PROPOSED RAMP  
 LAYOUT & DETAILS.

**PROPOSED  
 MODIFICATION  
 FOR TOILET FOR  
 HANDICAPPED.**

**FINAL PROPOSAL**

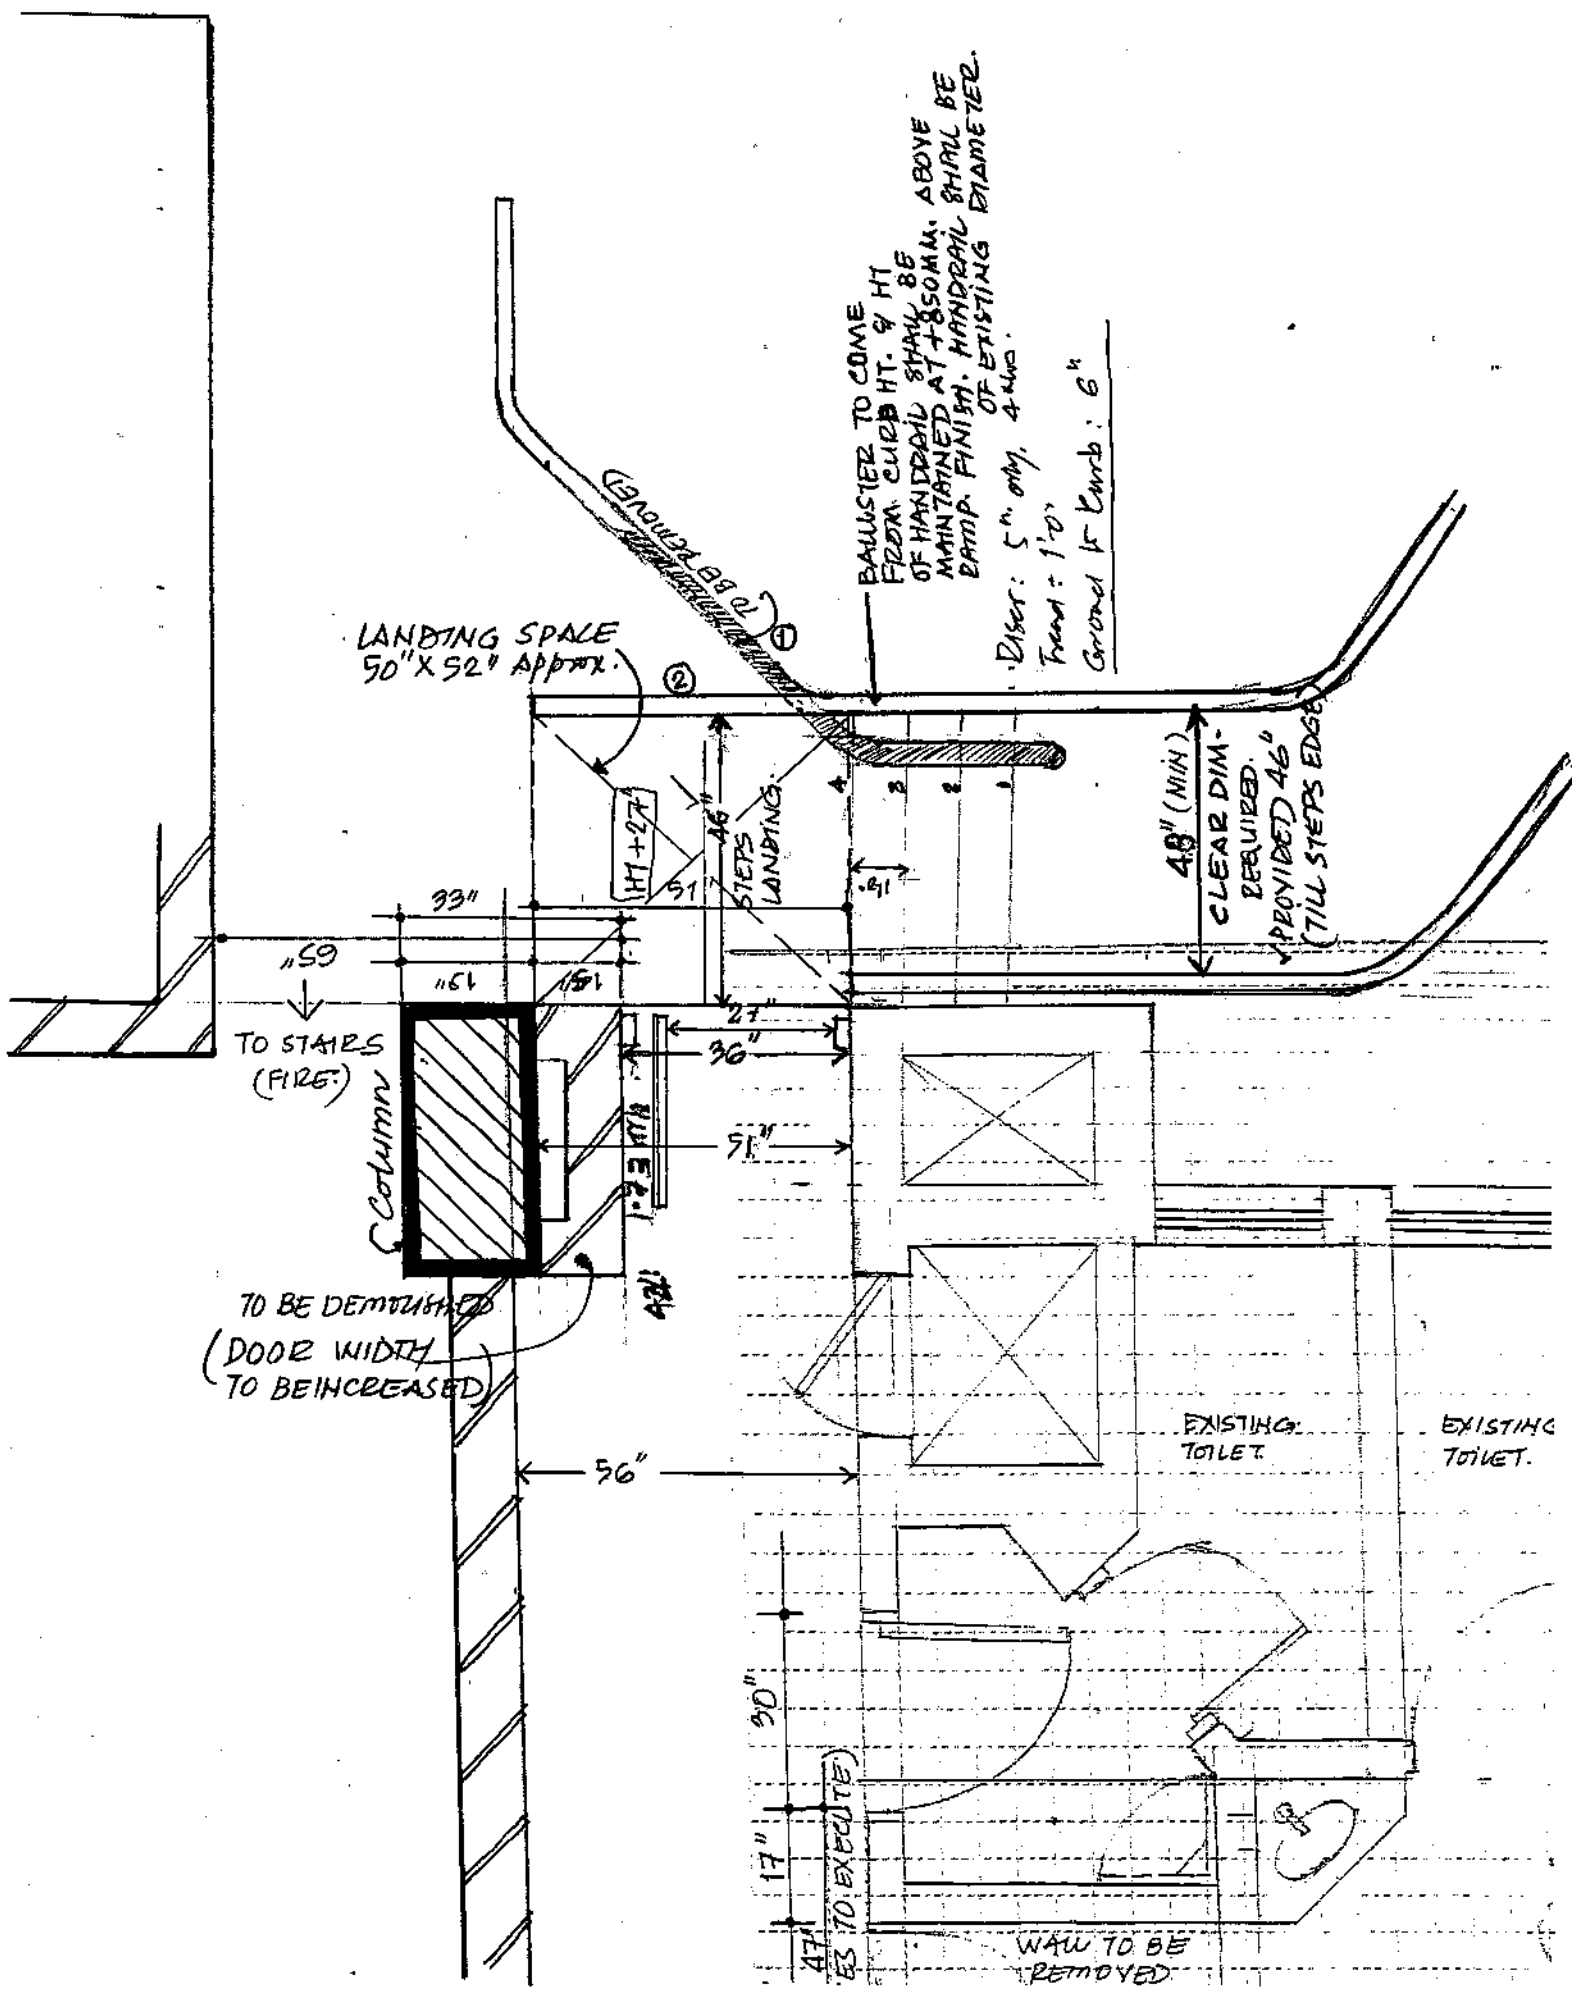
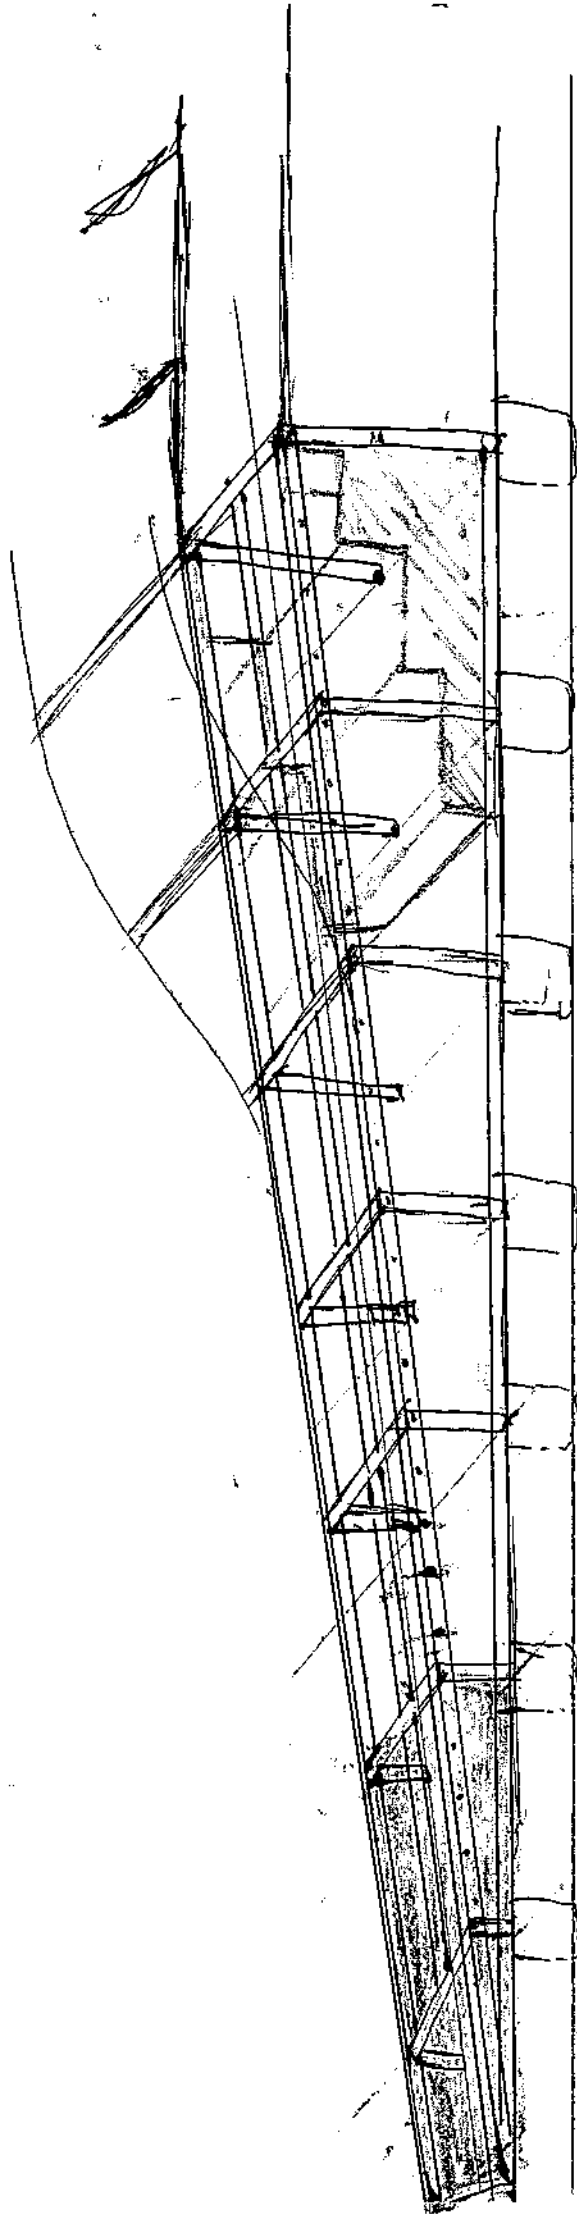
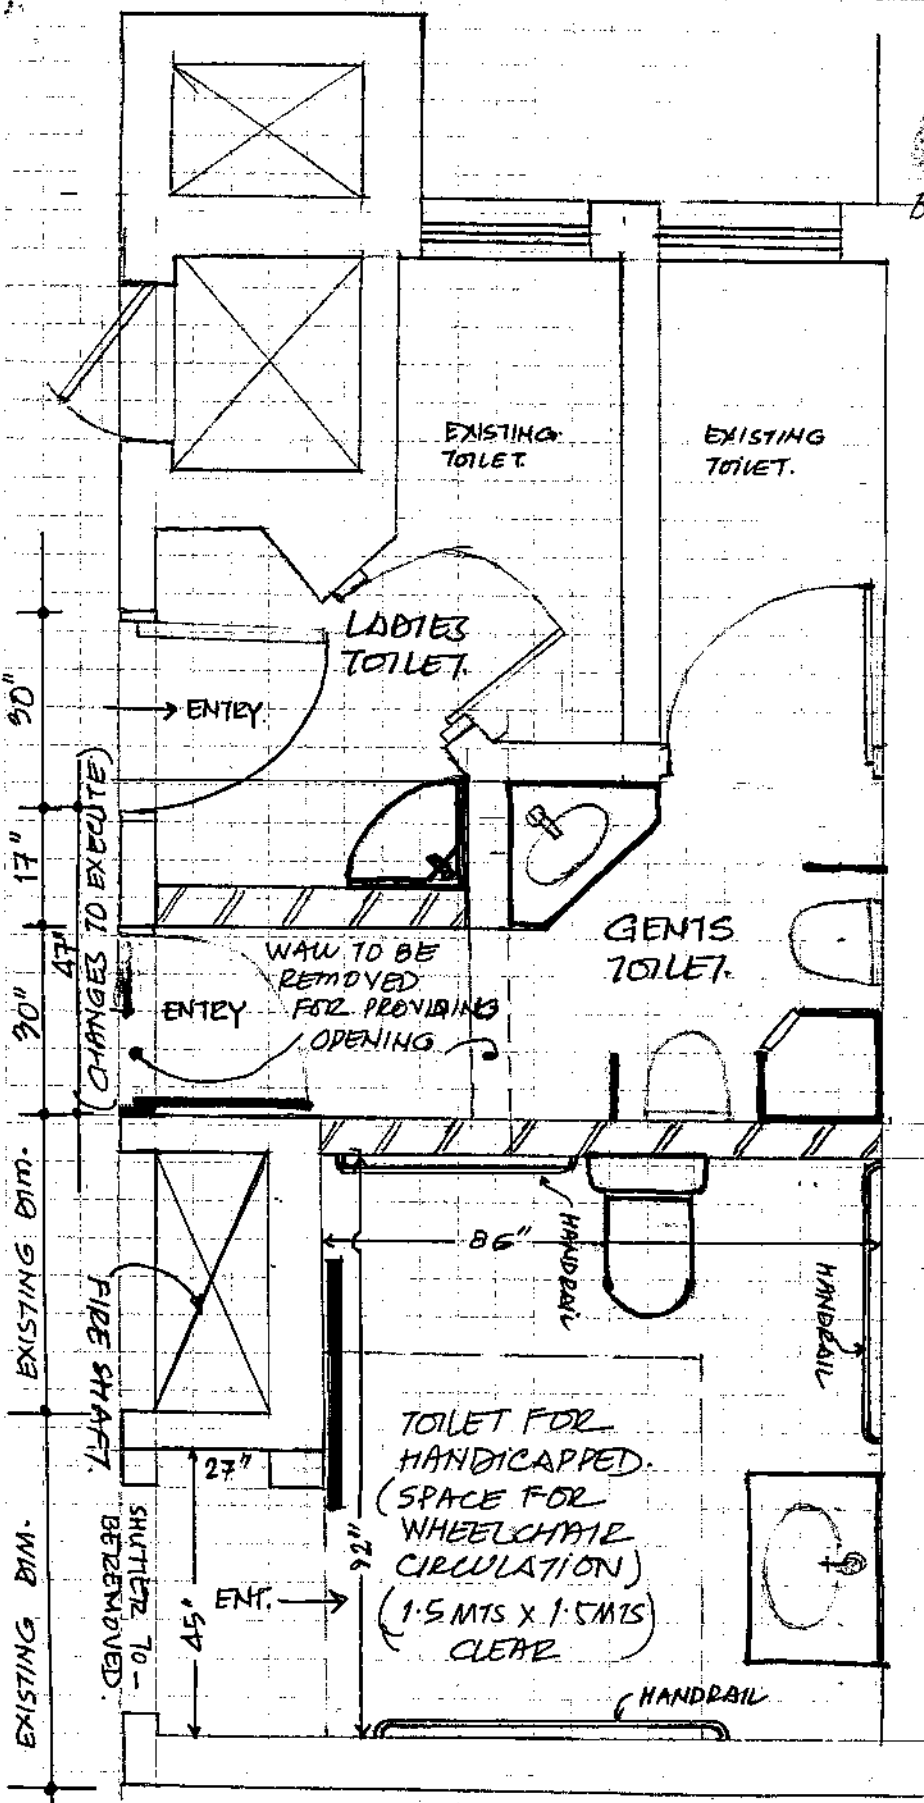
BAULSTER TO COME  
FROM CURB HT. 9' HT  
OF HANDRAIL SHALL BE  
MAINTAINED AT +850MM. ABOVE  
BAMP. FINISH. HANDRAIL SHALL BE  
OF EXISTING DIAMETER.

48" (MIN)  
CLEAR DIM.  
REQUIRED.  
PROVIDED 46"  
(TILL STEPS EDGE)

TO BE DEMOLISHED  
(DOOR WIDTH  
TO BE INCREASED)

WALL TO BE  
REMOVED
